TRIUNFO DO XINGU GROUPED REDD+ PROJECT VALIDATION REPORT

Document Prepared by Earthood Services Limited

Project Title	Triunfo do Xingu Grouped REDD+ Project
Version	1.4
Report ID	VCS.VAL.22.196

Report Title	Triunfo do Xingu Grouped REDD+ Project Validation Report
Client	SYSTEMICA INTELIGENCIA EM SUSTENTABILIDADE S.A.
Date of Issue	5-September-2025
Prepared By	Earthood Services Limited
Contact	B-1203, Tower B, Emaar Digital Greens, Sector 61, Gurugram, Haryana, India 122011 Tel: +91 124 4204599; Fax: +91 124 4204599 Website: www.earthood.in ; Email: operations@earthood.in
Approved by	Kaviraj Singh – Managing Director
Work carried out by	Pablo Rodríguez – Lead Auditor and Technical Expert Ana Beatriz Tukada – Technical and Local Expert

Figure 1. River and springs PPAs in the reference region with the properties and project areas.

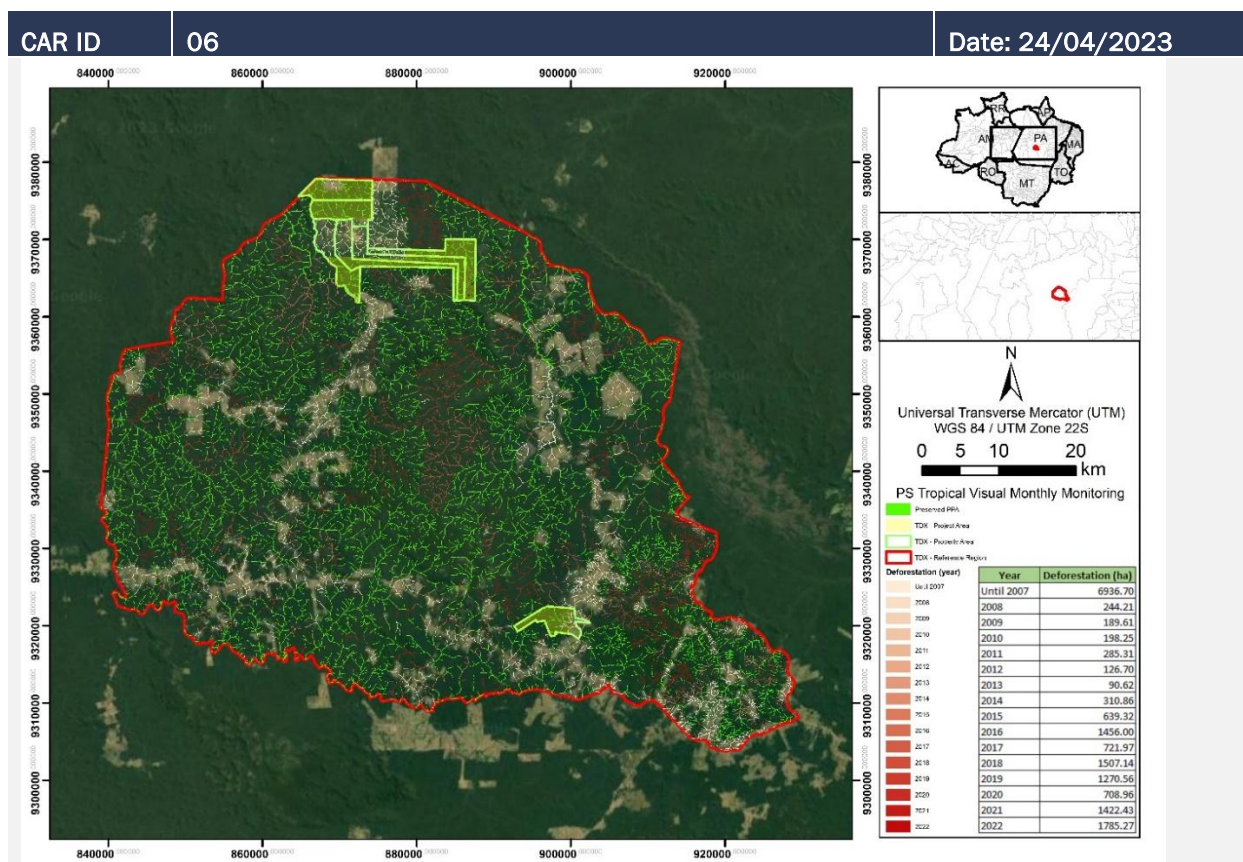
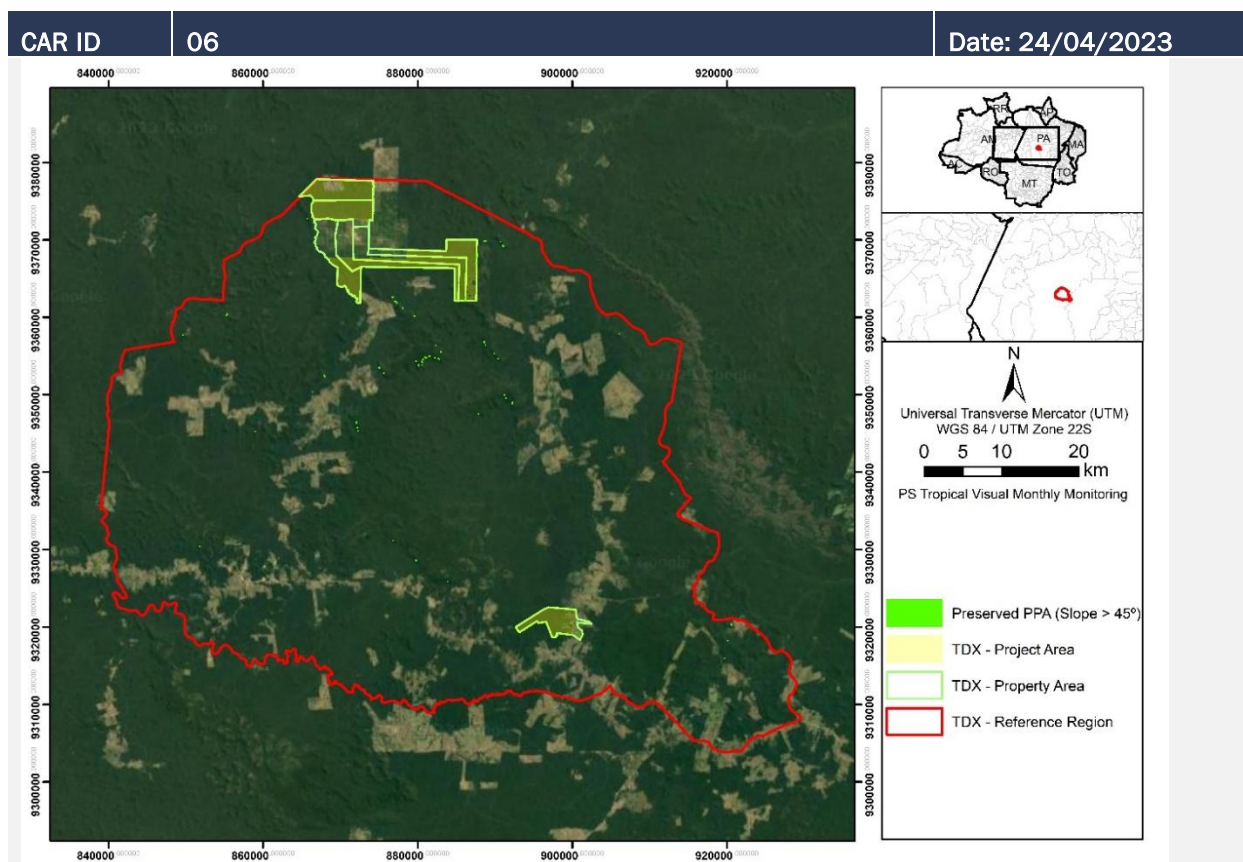
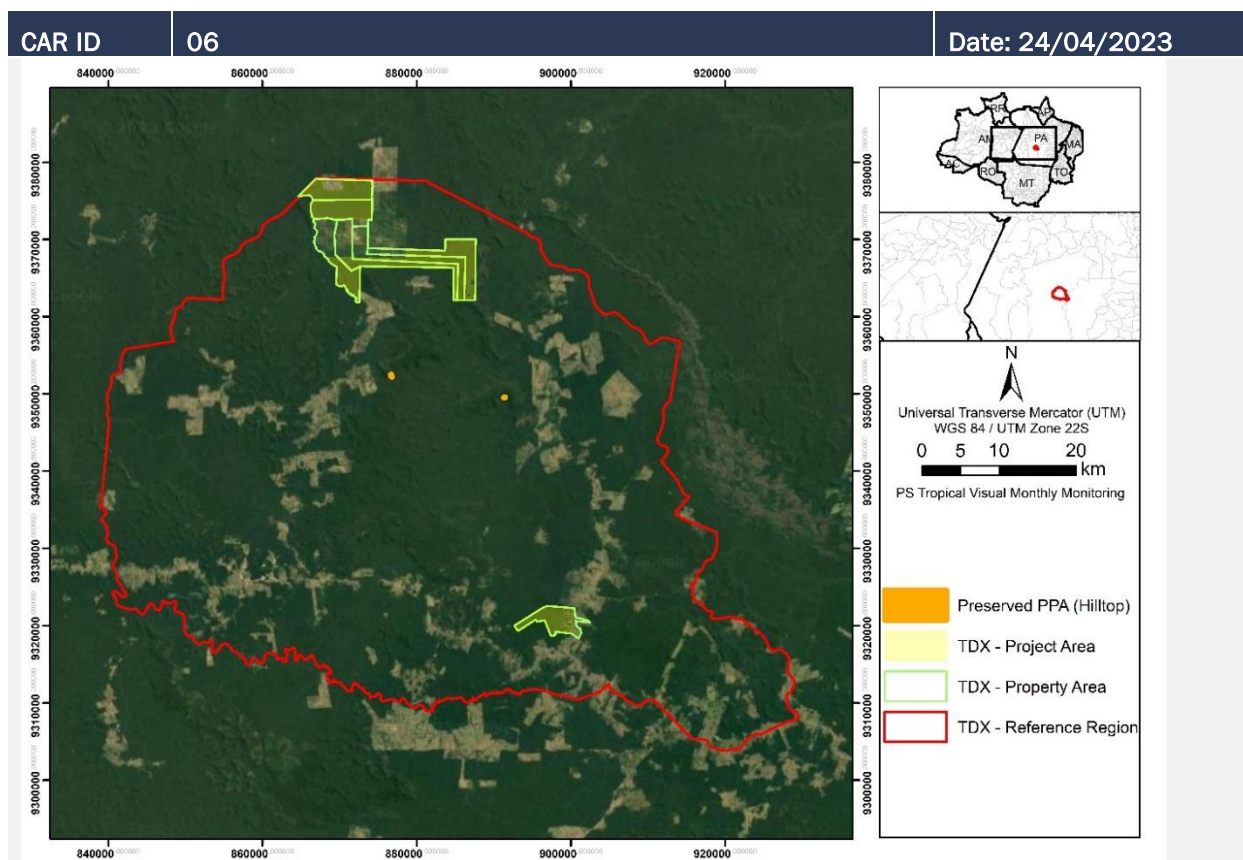
CAR ID	06	Date: 24/04/2023
"220812_Hydrography.shp":  It was mentioned during interviews with stakeholders that Didácio's property (Nossa Senhora Aparecida farm) has a river that runs close to the farm's headquarters and two springs within the forest area. However, according to the support "220812_Hydrography.shp", there are no rivers or springs on Didácio's property, only a river that runs on the southern border of Rafael Sefer's property. The Project Proponent did not demonstrate in PD v1.04 how Law No 12.651 of 25/05/2012 is being complied with in relation to APPs of rivers and springs. At the mapping scale of the project area, it is not possible to visualize whether APP areas are excluded, in compliance with legal requirements, according to the contents of section 3.3.2 of PD v1.04. 2. PD v1.04 section 1.13.4 states "Geology, Topography and Soils - About 75% of the project area has a slope <1 5 %, although slopes 1 5% are found in 25% of the areas, mainly to the east of the properties, and the altitude in the project area ranges from 169 to 500 meters. To obtain elevation and slope information, a mosaic of digit al elevation models, provided by NASA, with a spatial resolution of 30 meters (Farr et al., No areas above 500 meters were found within the project area (Figure 1.11)." Law Nº 12.651 of 25/05/2012, art. 4º states: <i>"Art. 4º Considera-se Área de Preservação Permanente, em zonas rurais ou urbanas, para os efeitos desta Lei: IX - no topo de morros, montes, montanhas e serras, com altura mínima de 100 (cem) metros e inclinação média maior que 25°, as áreas delimitadas a partir da curva de nível correspondente a 2/3 (dois terços) da altura mínima da elevação sempre em relação à base, sendo esta definida pelo plano horizontal determinado por planície ou espelho d'água adjacente ou, nos relevos ondulados, pela cota do ponto de sela mais próximo da elevação;"</i> The Project Proponent did not demonstrate in PD v1.04 how Law No 12.651 of 25/05/2012 is being complied with about the top of hills ("topo de morros") APPs.

Project participant response		Date: 22/05/2023
1. The analyses conducted, geoprocessing data used as support are in the folder "230515_APP_with_deforestation.zip" shows how the legislation regarding the APPs of rivers and springs is being complied with. An intersection/overlapping of these areas was made with PRODES (INPE, 2022), deforestation data, and a year-to-year survey of deforested areas was conducted. After the analysis, was found that there is deforestation occurring in riparian and spring protection areas throughout the reference region and project area (Figure 1), because overlapped occurred between deforestation and rivers and springs APP. It In the project areas, degraded protection areas have old deforestation, as shows the table in Figure 1. The new shapefile "230515_Hydrography.zip" represents on a smaller scale hydrography and springs in the RR.

- To comply with Brazilian legislation regarding the protection of areas with steep slopes (areas with 45 degrees or more of inclination), an analysis of sloping areas was carried out based on the digital elevation model, geoprocessing data used as a support are in the folder "230515_APP_slope". An intersection/overlapping of these areas was made with PRODES (INPE, 2022), deforestation data, and a year-to-year survey of deforested areas was conducted. The sloping areas found in the project area and the reference region are preserved, because no overlapped occurred between deforestation and slope APP (Figure 2).

Similarly, an analysis of hilltop areas for protection was carried out, following Brazilian legislation. An intersection/overlapping of these areas was made with PRODES (INPE, 2022), deforestation data, and a year-to-year analysis of deforested areas was conducted. After the analysis, the sloping areas found in the project area and the reference region are preserved, because no overlapped occurred between deforestation and slope APP (Figure 3), geoprocessing data used as support are in the folder "230515_APP_slope".

Figure 1. (230724_TDX_APP_PRODES_MapBiomass_2022_Didacio.jpeg) Map showing APPs at Didácio's property and its surroundings, colored according to PRODES deforestation classes, and the relevant land-use classes from our base maps derived from MapBiomass.

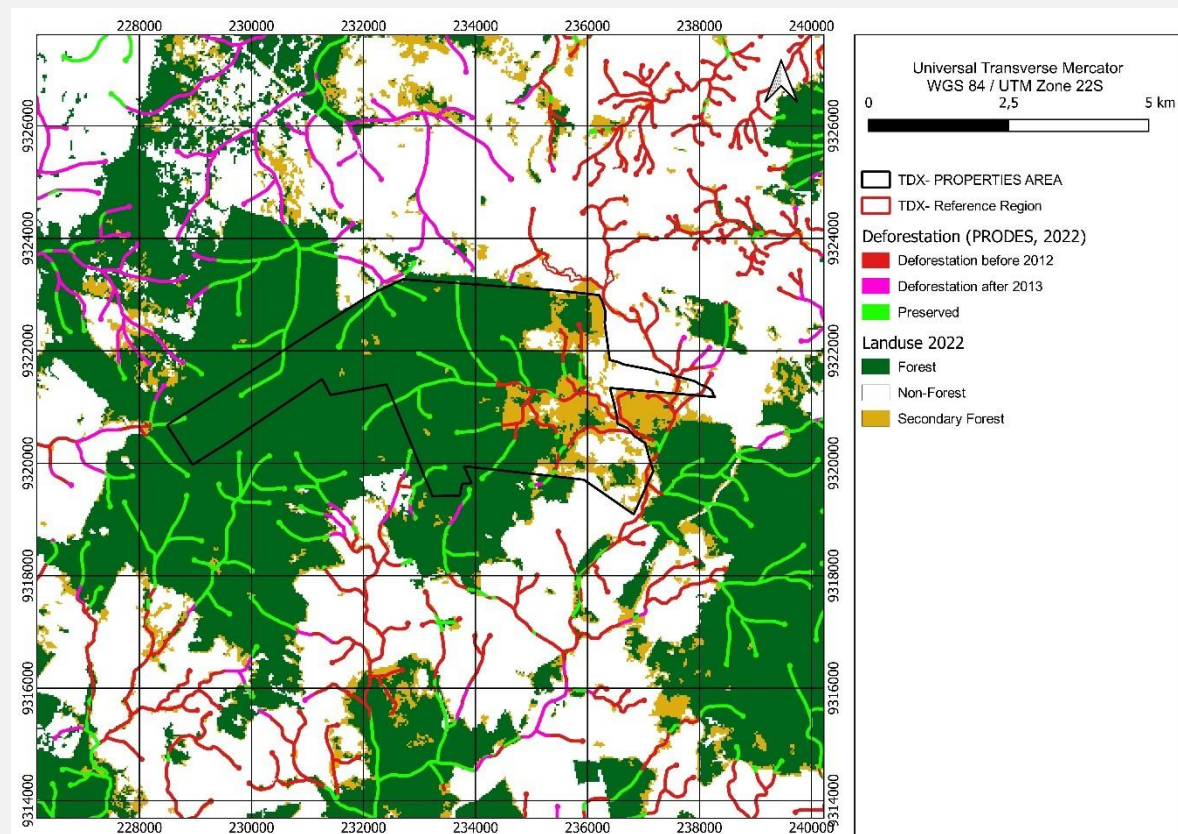
Consider the case of Didácio's farm, depicted in Figure 1. It can be observed that APPs were deforested within property boundaries before 2012 (in fact, before 2007; see the annexed high-resolution map "230724_TDX_APP_PRODES.jpeg"), and that a significant amount of regeneration has taken place in the affected areas (evidenced by large patches of "Secondary Forest" class), with even fully regenerated eligible forests appearing where once deforestation occurred. In this case, the regeneration further increases discrepancies between PRODES and MapBiomass coverage classes. Again, these discrepancies between independent dataset are perfectly normal and expected.

Figure 2. (230724_TDX_APP_PRODES_MapBiomas_2022_Sefer.jpeg) Map showing APPs at Sefer's property and its surroundings, colored according to PRODES deforestation classes, and the relevant land-use classes from our base maps derived from MapBiomas.

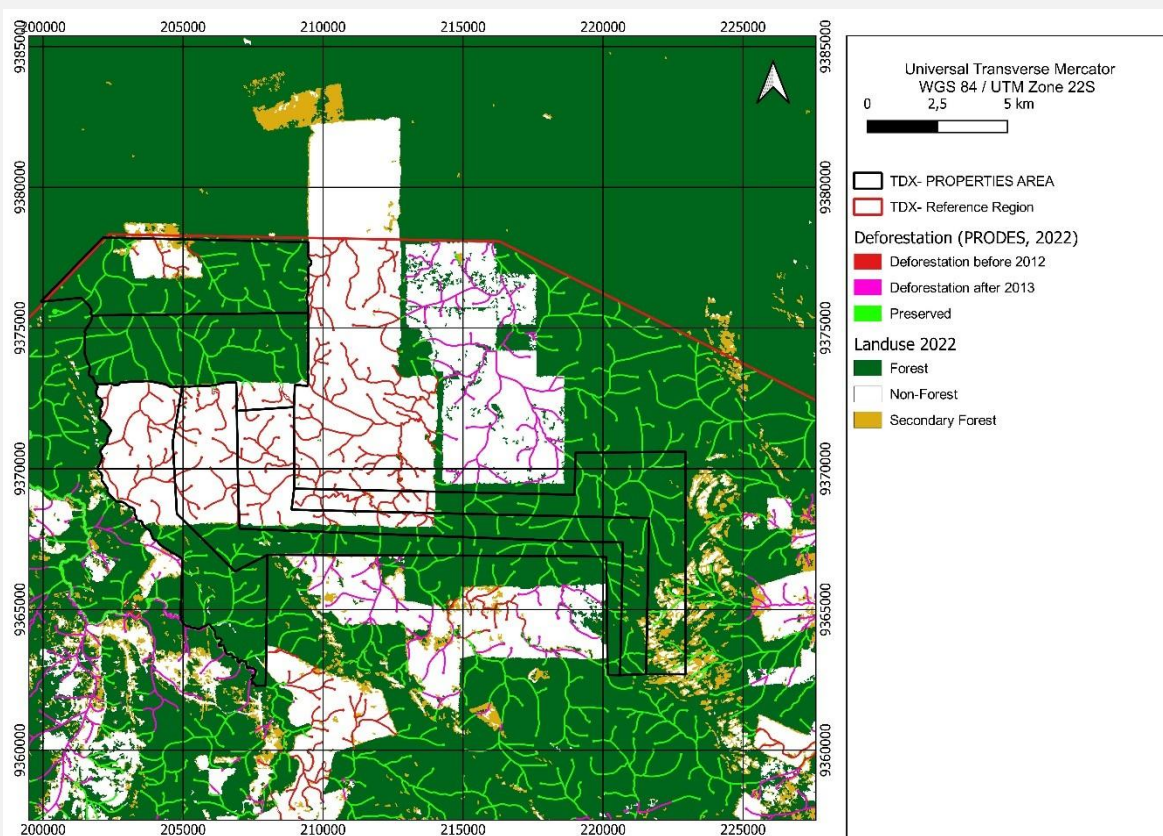
The reviewer refers to Sefer's property; the farms and its surroundings are depicted below in Figure 2, with APP areas superimposed. Once more, it is possible to observe that APPs within property boundaries have been deforested before 2012 (in fact, before 2007; see the annexed high-resolution map "230724_TDX_APP_PRODES.jpeg"). Here the agreement between PRODES and MapBiomas is better, partly because affected areas don't display signs of regeneration. Indeed, in this case, the origin of the conflict noted by the reviewer seems to be much trivial: in the zoomed-in snapshot added in the comment property boundaries are represented with thick lines and do not allow a proper distinction between APP segments inside and outside the project area. When the map is analyzed at better resolution one concludes that recently deforested/degraded APPs are, in fact, located outside the property (except, of course, for possible tiny discrepancies due to the use of the independent datasets).

1.b) Considering that the APP areas are of legal compliance, it is not clear why the Project Proponent did not exclude these areas from the project and it is mandatory that the owner preserve the APPs.

Figure 0.15 TdX Forest cover map with PPAs – Didácio Milhomens' property

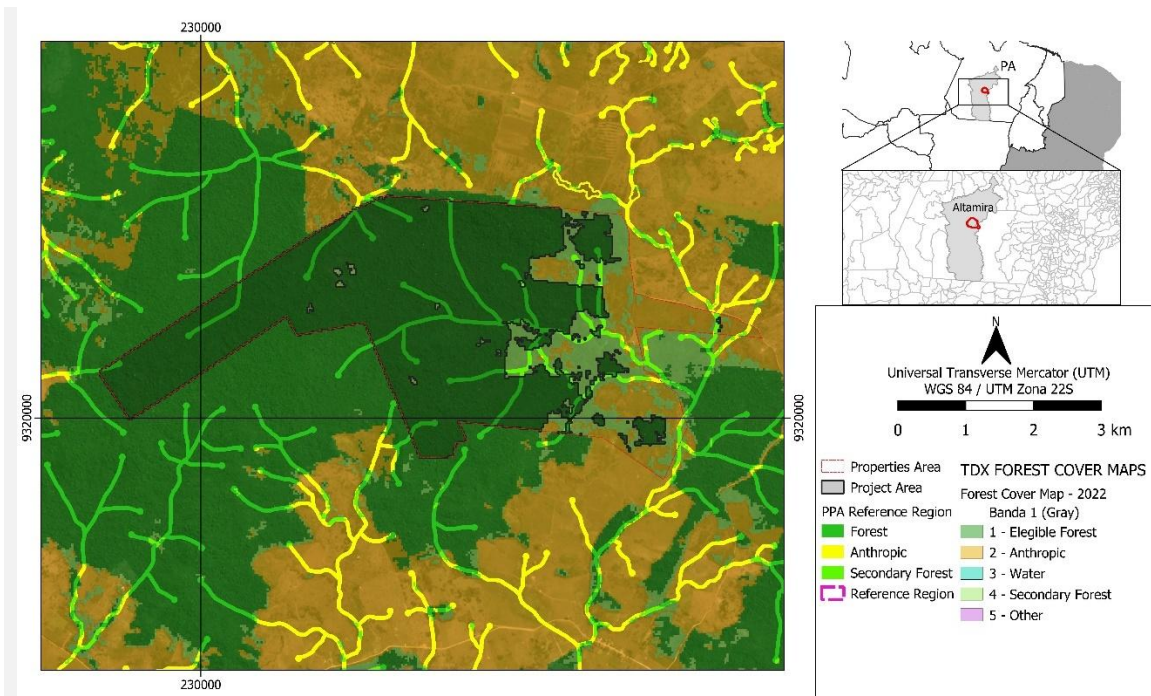
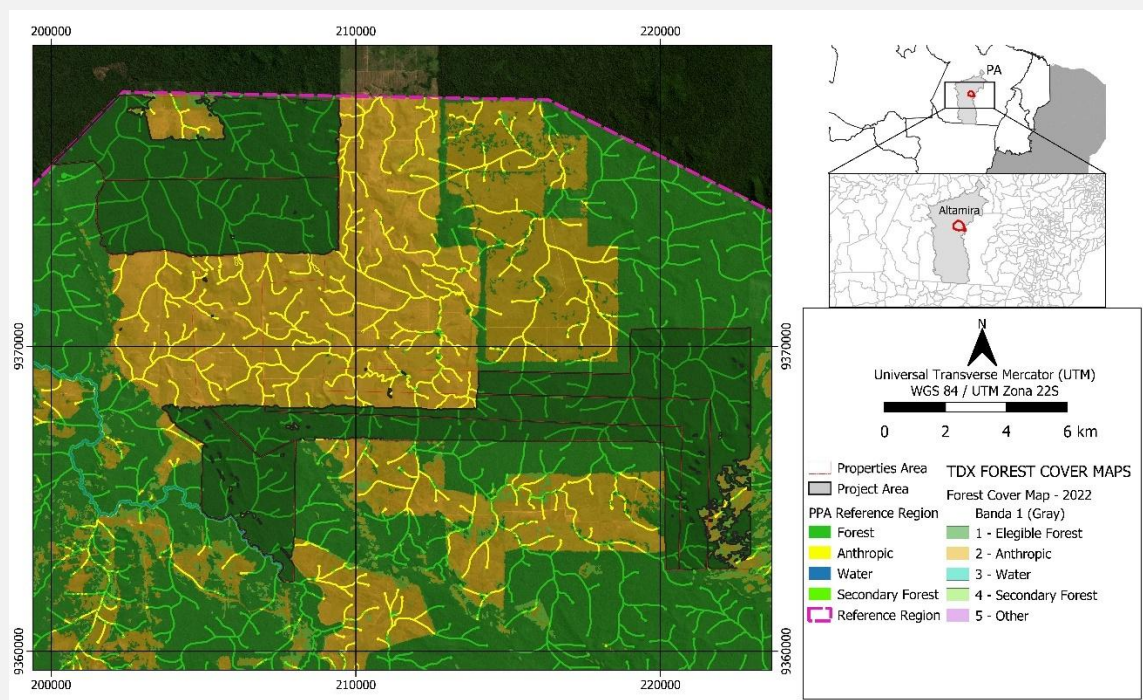
"As shown in Figure 0.15 and Figure 0.16, a relevant part of the project area consists of permanent protection areas (PPAs). Within the Didácio Milhomens' property, 101.24 ha are PPAs out of the 1,406.79 ha of eligible forest, i.e., 7.2% of the project area. Similarly, in Rafael Sefer's properties, 893.93 ha are PPAs out of the 9,229.23 ha of eligible forest, i.e., 9.7% of the project area. Therefore, considering the complete first project instance, 995.20 ha of PPAs are part of the 10,636.02 ha of project area, that is, the PPAs represent 9.4% of the total project area. As discussed respectively in sections 3.4 and 3.5, AUD activities on PPAs are additional and, consequently, the deforestation of these areas is part of the project baseline scenario."

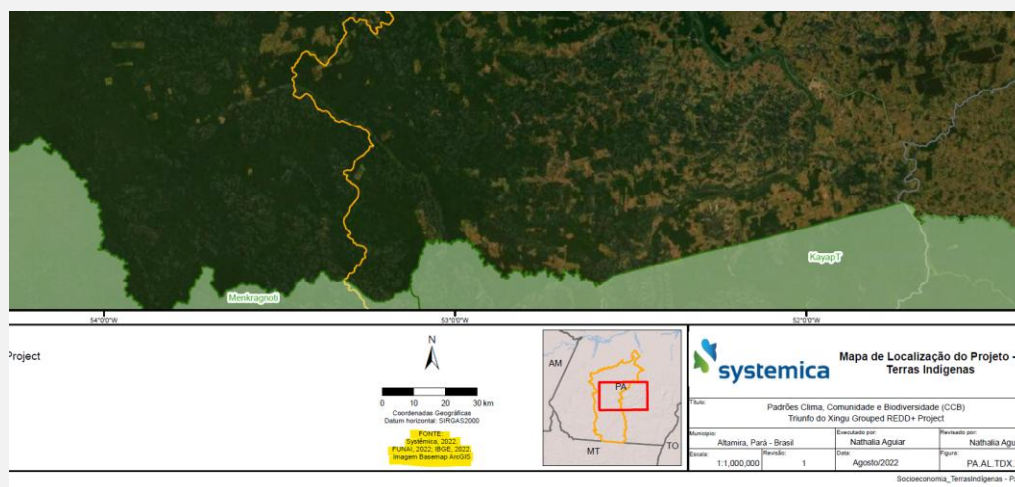
1. **Reference with data from the Brazilian Amazon Biome x Reference with data at the Brazilian level and different periods.** In the first paragraph of the text we use the values at the Brazilian level, but the print refers to the values at the level of the Brazilian Amazon biome. In the second paragraph, the values refer to a different period than in the print.

The print screen has been redone. The reference to the values in the first paragraph has been readjusted to the Brazilian territory level.

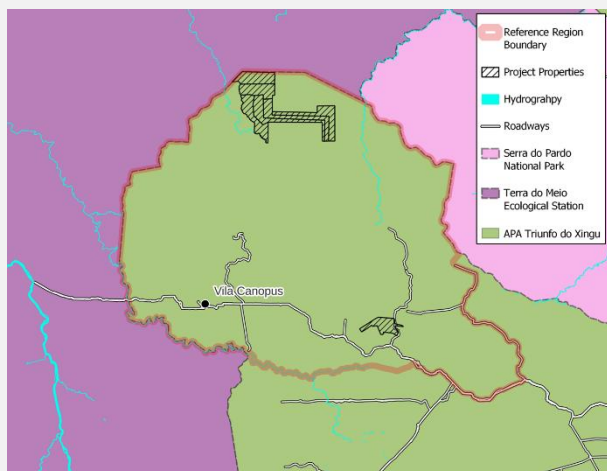
1. [...] it is not completely supported why the Project Proponent included the mining area in the Reference Region and what is the similarity of this agent and driver of deforestation within the Project Area.

We should also mention that the TdX RR boundary is defined according to clear and straightforward geographic criteria. (Since the prevalent agents and drivers are common to most deforestation frontiers in the Brazilian Amazon, the primary criteria for defining reference regions tend to be, in practice, related to topographic and land tenure factors.) As depicted in the figure below, the RR is simply the part of APA Triunfo do Xingu (a sustainable use conservation unit where all project properties are located) limited in its southern border by a river, and in its southeast border by a set of interlinked roadways (also satisfying all the methodological requirements of relative size and similarity to project areas).

The above figure makes clear that removal of Vila Canopus from the RR would result in a failure to properly capture the effects of rivers and road infrastructure, both important variables when designing baseline models.

- The text in [section 3.3.3](#) (which indeed contained ambiguities) was corrected and now it clearly distinguishes between historical and currently active agents of deforestation in the region.
- The first figure presented in this item, which illustrates the expansion of pasturelands around Vila Canopus, was added to the PD, clarifying the discussions related to the role of the mining site in the RR ([Figure 3.3](#) in the updated version).
- The second figure, that illustrates the criteria used to define the RR boundary, is included in the updated annex "[230518 TDX-Annex-Historical Maps.pptx](#)".
